STATE OF NORTH CAROLINA
DEPARTMENT OF TRANSPORTATION

September 30, 2025

SUBJECT: Request for Modification of the Phased Section 404 Individual Permit and Section 401 Individual Water Quality Certification for the construction of the Triangle Expressway Southeast Extension from NC-55 Bypass in Apex to I-40, Wake and Johnston Counties. TIP Nos.: R-2721, R-2828, and R-2829. Federal Aid Project No. 0540047.

We are requesting a modification to Section 404 Authorization (SAW-2019-02240) and the associated 401 Individual Water Quality Certification (Permit No. 20181249). This request is prompted by several areas changing from one wetland impact type to another (e.g. mechanized clearing to excavation) or temporary stream impacts changing to permanent stream impacts for bank stabilization purposes. Also, additional impacts are needed for a ditch tie-in at Wetland WHG, which was removed during the 4B meeting, but is being added back in as a permit site (Site 13). Details of why these changes are being made are provided below.

PERMIT DRAWING SHEET 77 OF 112

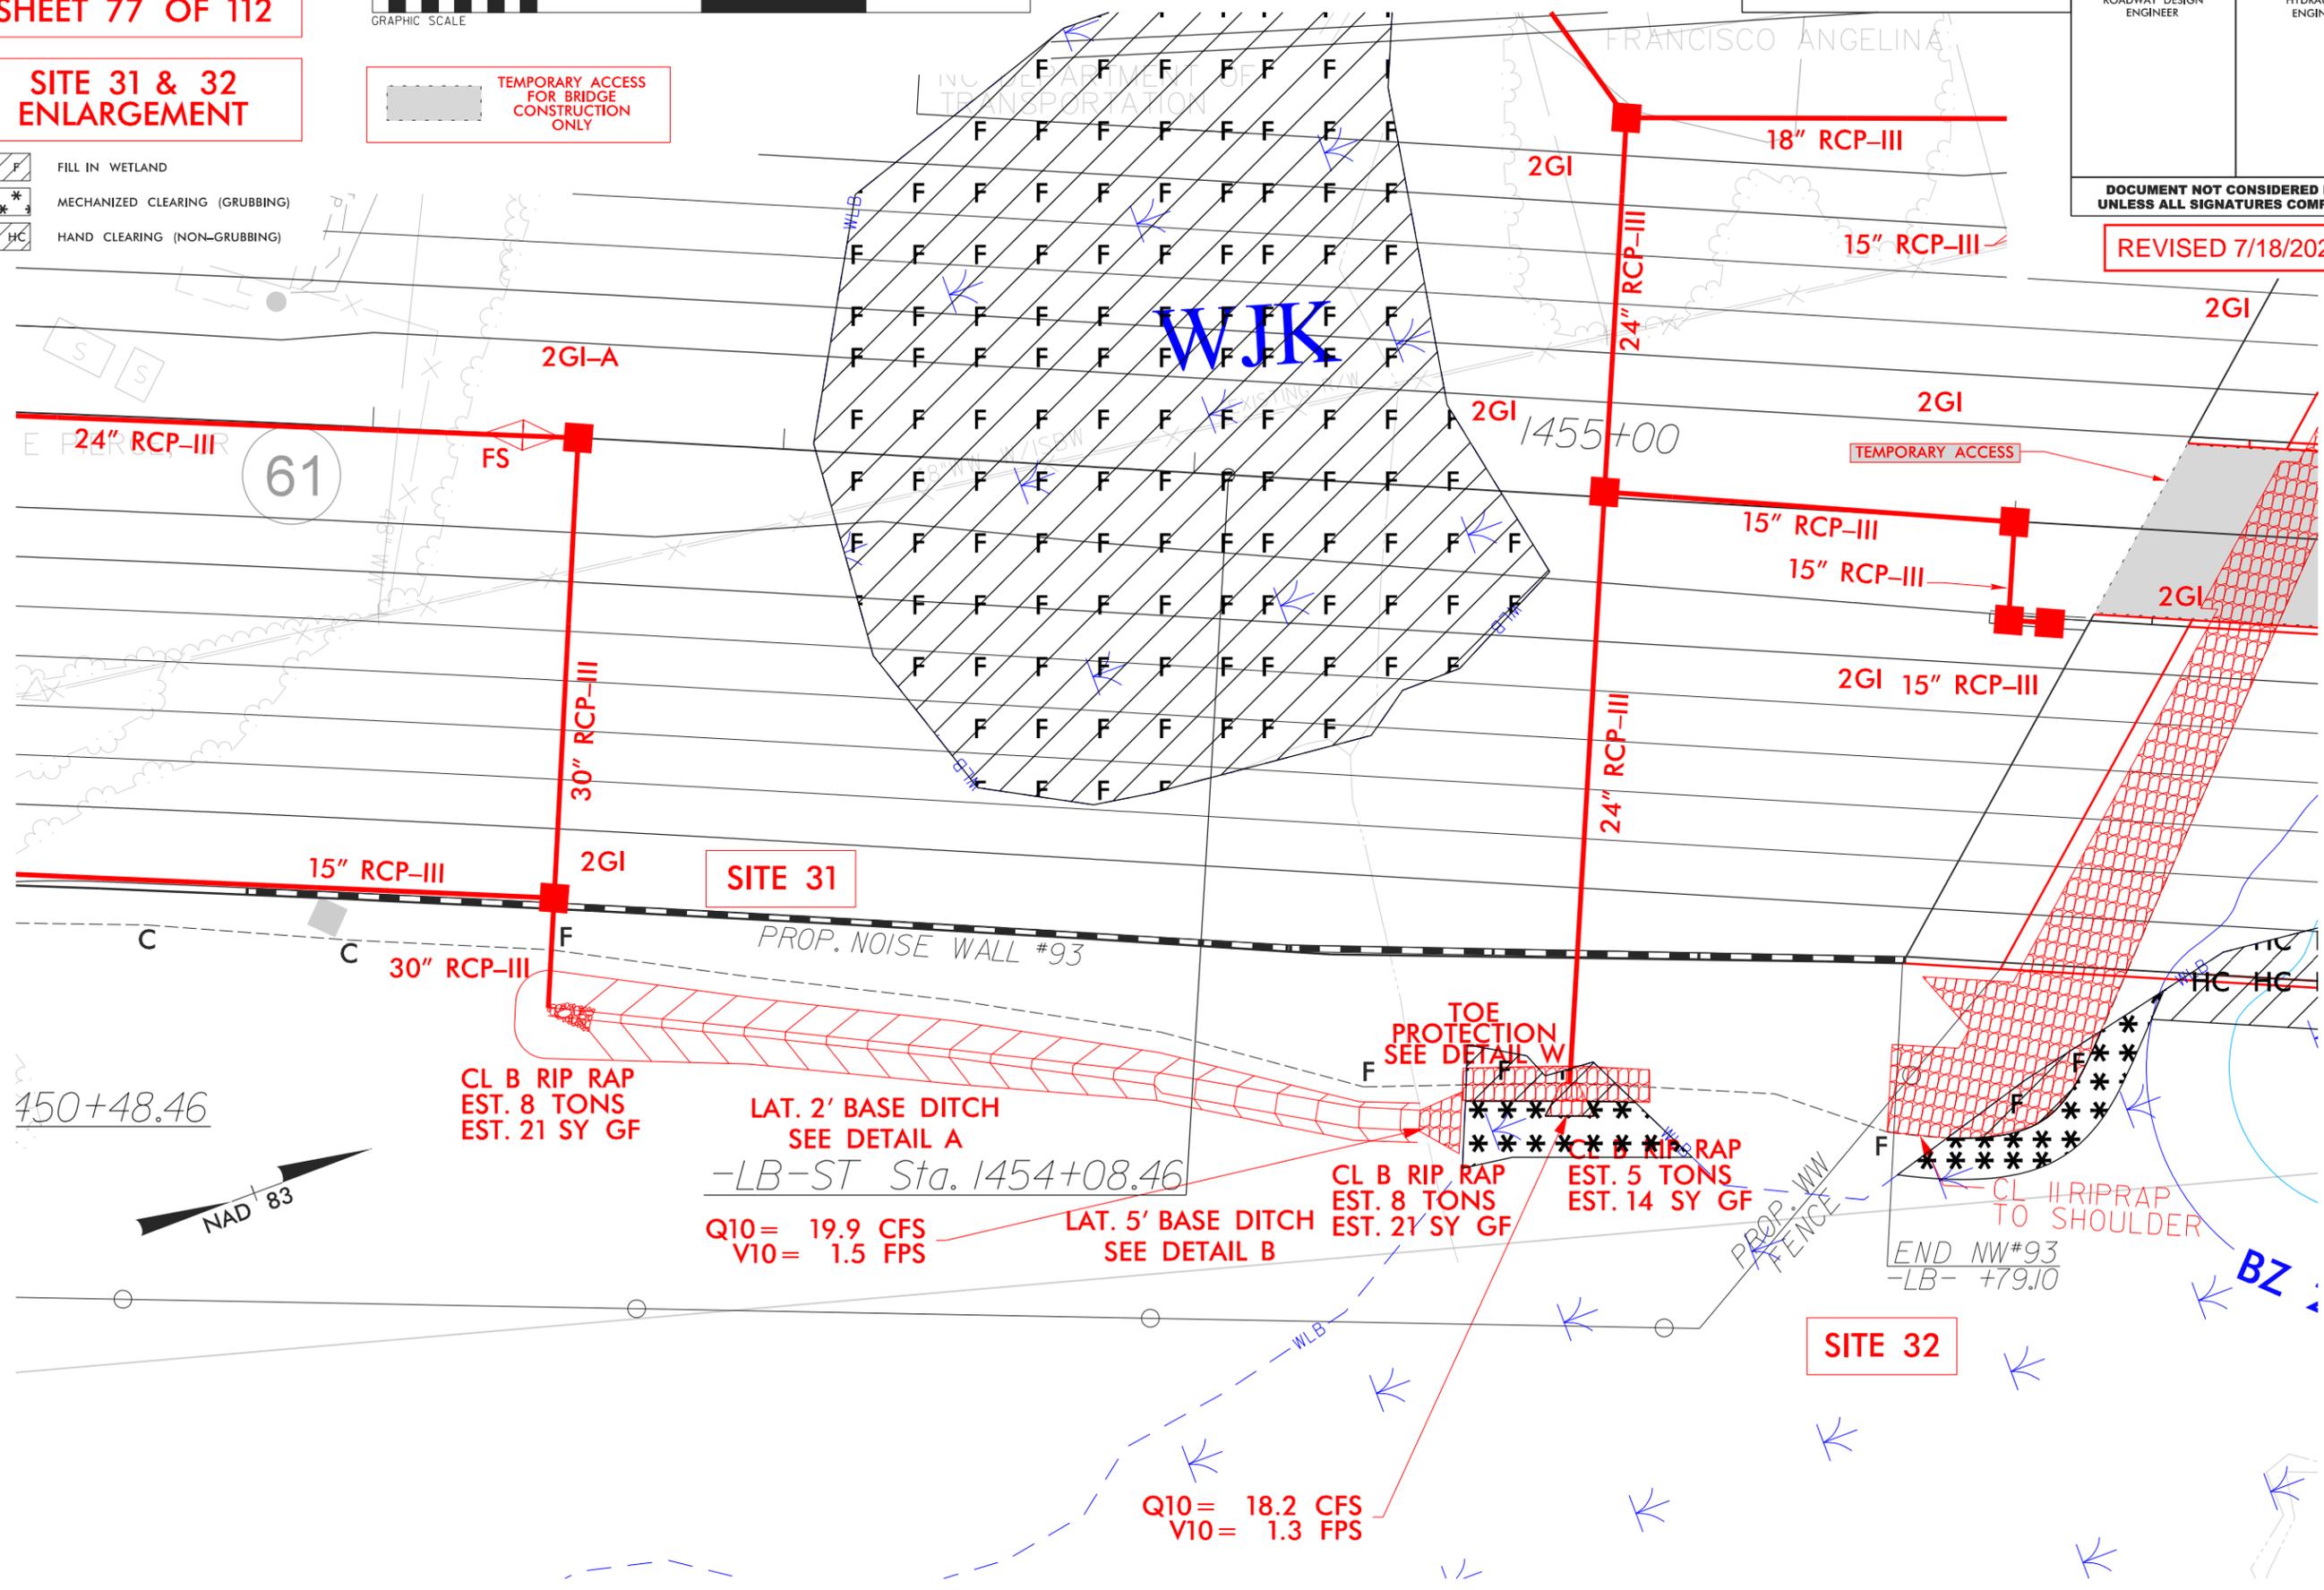
- Permanent Fill in Wetland: 0.615 ac (previously 0.612) – Increase of 0.003 ac
- Mechanized Clearing in Wetland: 0.015 ac (previously 0.002) – Increase of 0.013 ac
- Total Mitigable Impacts: 0.630 ac (previously 0.614) – **Increase of 0.016 ac**

A small area of Mechanized Clearing in Wetlands has been modified to Fill in Wetlands where the toe protection has been extended. It appears that the original measurement of Mechanized Clearing in Wetlands was incorrect, so the total Mechanized Clearing in Wetlands has also increased to accurately represent the area shown on the permit drawings.

SITE 31 & 32 ENLARGEMENT

PERMIT DRAWING SHEET 79 OF 112

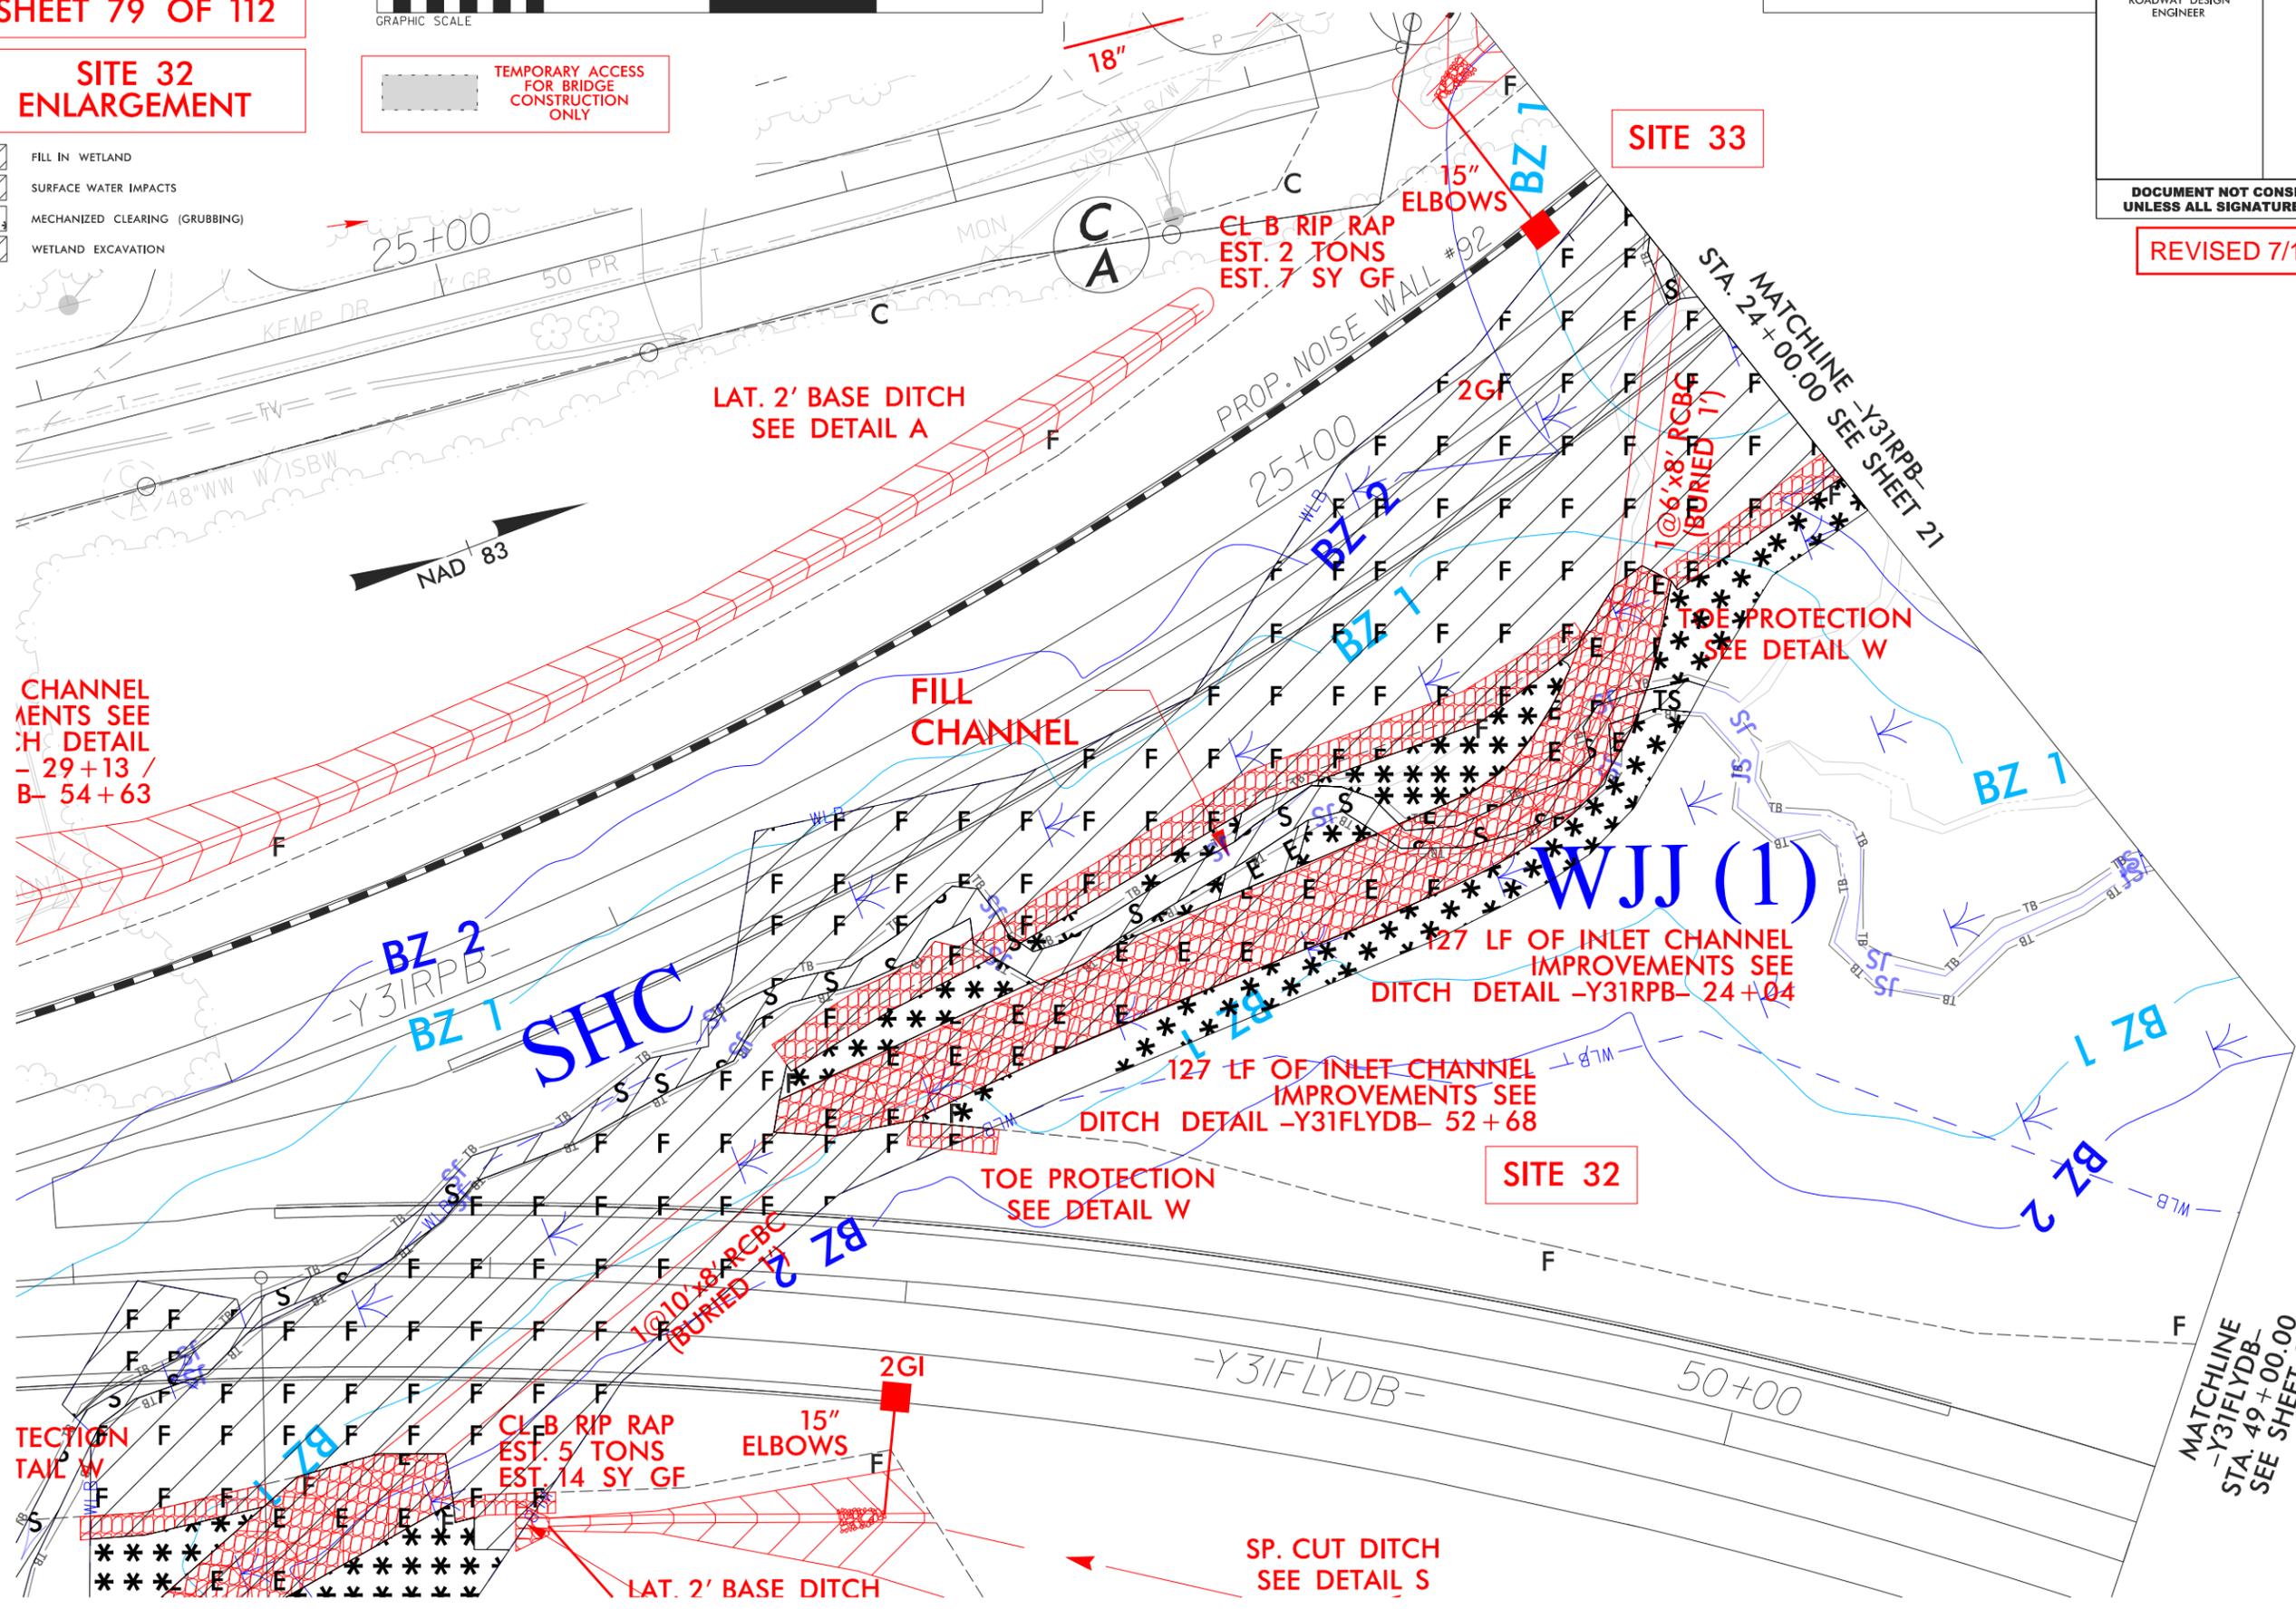
- Permanent Fill in Wetland: 0.218 ac (previously 0.212) – Increase of 0.006
- Excavation in Wetland: 0.048 ac (previously 0.040) – Increase of 0.008 ac
- Mechanized Clearing in Wetland: 0.101 ac (previously 0.115) – Decrease of 0.014 ac
- Total Mitigable Impacts: 0.367 ac (previously 0.367) – **No Change**
- Permanent Stream Impact (Bank Stabilization): 195 lf (previously 0)
- Temporary Stream Impact (Causeway): 74 lf (previously 269)
- **No Net Change**

No new impacts are required at Site 32. A small area of Mechanized Clearing in Wetlands has been modified to Excavation in Wetlands and Permanent Fill in Wetlands. The planned temporary diversion has been adjusted to better coordinate the culvert sequencing within this area. This change in impacts is a result of the revised culvert sequencing plans approved by the NCTA Resident Engineer’s Office, NCDOT REU, and NCTA’s environmental consultants. In addition, several areas of Temporary SW impacts have been converted to Permanent SW Impacts due to the potential for additional bank stabilization being necessary once the temporary pipes are removed from under the construction access causeways.

SITE 32 ENLARGEMENT
